Timing Gear Components: **Hyundai/Kia: 1.8L & 2.0L: G4NA, G4NB, G4NC & G4KD Engines**

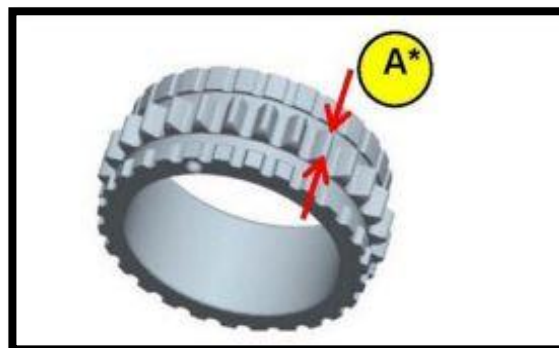
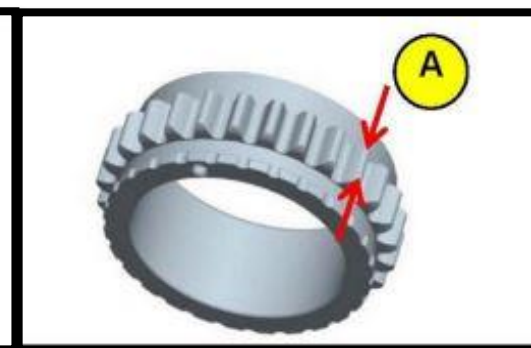
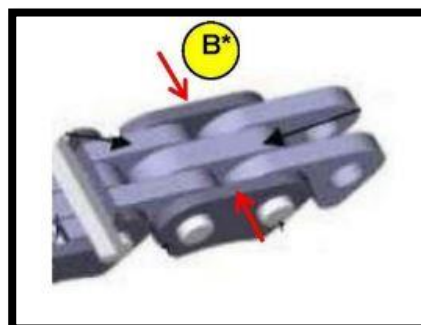
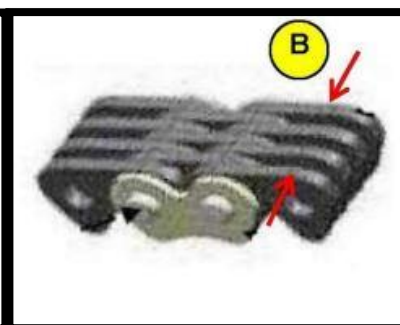
NTC21 & HYTK31 include 6.30mm chain width & NTC12 & HYTK23 include 8.65mm chain pitch- refer to measuring point diagrams

Whenever changing timing components and VVT assemblies, carefully inspect components being removed and being replaced, ensuring the correct width profile of all three components are matching. Failure to do so will cause immediate engine damage.
